**LEROY STREET
ROAD SAFETY ASSESSMENT**

**CITY OF BINGHAMTON
BINGHAMTON METROPOLITAN TRANSPORTATION STUDY
AUGUST 2024**

Chestnut Street and Leroy Street

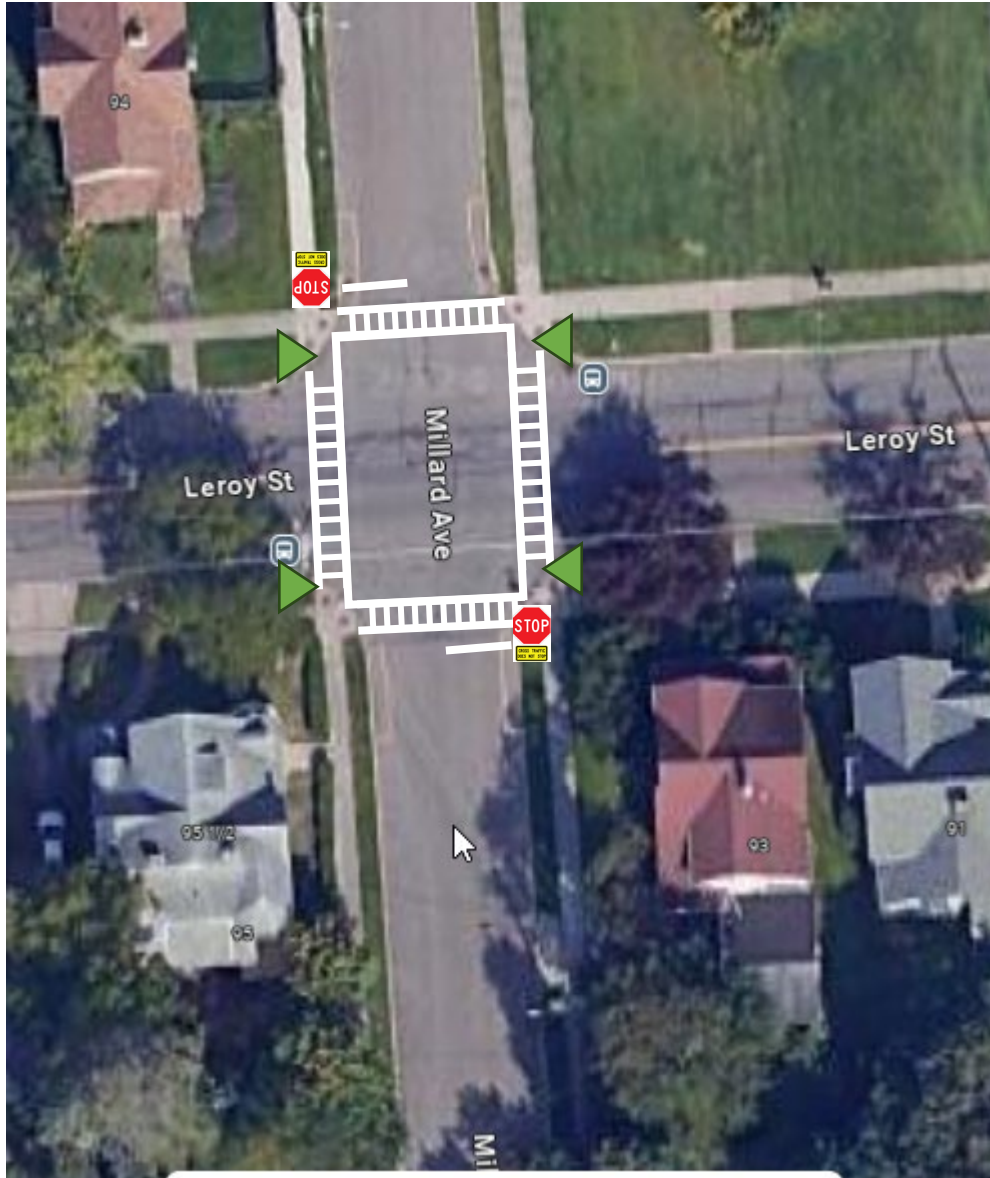
Four-way stop-controlled intersection controlled with a traffic signal
15 total reported crashes however there was no clear crash pattern other than striking of parked vehicles

1. Add 'No Parking Here to Corner' signs and associated pavement markings, marking and signage are either missing or noncompliant with setbacks at some of the intersection approaches
 - parking is prohibited within 30 feet of an intersection per the City's Vehicle and Traffic Code
